Office Action Summary

10/582,046

STROBEL, GUSTAV

DETAILED ACTION

Annotated Figure 3 (Weidner)

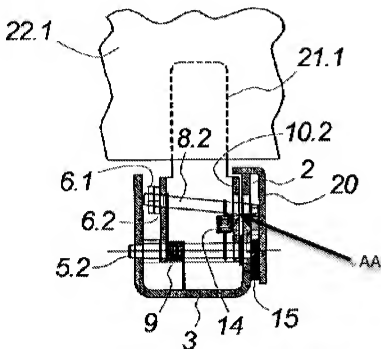
Regarding **Claims 13 and 18-22**, Weldner teaches: **Claim 13** – a stacking column comprising two side walls (2) and latches (21.1-21.3) arranged between the side

walls (2) on a pin (5.1-5.3) for rotation between a rest position into a working position, wherein the latches (21.1-21.3) are assigned a locking device (6.1-6.3, 8.1-8.3, 12.1-12.4 and 13.1-13.4) which fixes at least some of the latches (21.1-21.3) in the working position, (Figures 3 and 4); **Claim 18 (Dependent upon Claim 12)** – wherein a supporting part (10.1-10.4) is provided downstream of the pin holder on the latch (21.1), (Figure 3); **Claim 19** - wherein the supporting part (10.1-10.4) has a cutout (AA) for receiving part of the locking device (8.2), (Annotated Figure 3 Below); **Claim 20** – wherein a stop lug (10.2) projects from the upper part of the cutout (AA) to stop part of the locking device (8.2) from leaving the cutout (AA), (Annotated Figure 3); **Claim 21** – wherein the locking device (8.2) moves (between slots portions 12.4 and 13.4) in the cutout (AA) by means of a small rail (8.2), (Figure 4 and Annotated Figure 3); **Claim 22** – wherein the small rail (8.1-8.4) is part of a lever linkage (6.1-6.4) which moves in the manner of a “parallelogram” and similarly to the applicants device as seen in applicants Figures 1-7, (Figures 3 and 4).

Annotated Figure 1 (Scholler)

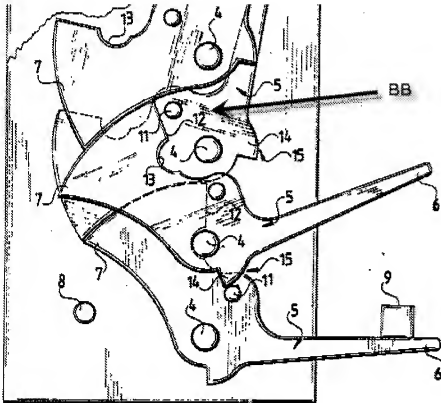
10. Claims 12, and 14-18 are rejected under 35 U.S.C. 103(a) as being unpatentable over DE Patent No. 3811310 (Scholler) in view of U.S. patent no. 5,373,756 (Schoeller).

Regarding **Claims 12 and 14-18, Scholler** teaches: **Claim 12** – a stacking column comprising two side walls (2 and 3) and latches (5) arranged between the side walls (2 and 3) on a pin (4) for rotation between a rest position into a working position, wherein at least some of the latches (5) have a pin holder surrounding the pin (4), (Figures 1 and 2); **Claim 14** – wherein at least two adjacent pins (4) maintain a distance from each other which is greater than and substantially the same as a material thickness (BB) of the latch (5) in the region (BB) of the pin holder, (Annotated Figure 1 Below); **Claim 15** – wherein the latch (5) is of a single piece design, (Figures 1 and 2); **Claim 16** – wherein a driver (7 and 12) protrudes from each of the latches (5) downstream of the pin holder, and when the latches rotate about the pin (4), the driver (7 and 12) acts on an adjacent latch (5) to move the latch (5) into a standby position, (Figure 1); **Claim 17** – wherein the drivers (7 and 12) of successfully following latches (5) are arranged in an alternating manner in the vicinity of respectively opposed side walls (2 and 3), (Figures 1 and 2); **Claim 18** – wherein the supporting part (6) is provided downstream of the pin holder, (Figure 1).

Scholler does not teach: wherein the latch has a pin holder which only partially surrounds the pin in an arcuately curved manner (**Claim 12**). However, **Schoeller** teaches: **Claim 12** - a latch (1) for use in a stacking column wherein the latch has a pin holder (5) which only partially surrounds a pin in an arcuatley curved manner, (Figure 1). Therefore, it would have been obvious to one of ordinary skill in the art to modify the stacking column of **Scholler** to have the latch having a pin holder which only partially surrounds the pin in an arcuately curved manner (**Claim 12**) as taught by **Schoeller** for the purpose of being able to easily replace a damaged latch.
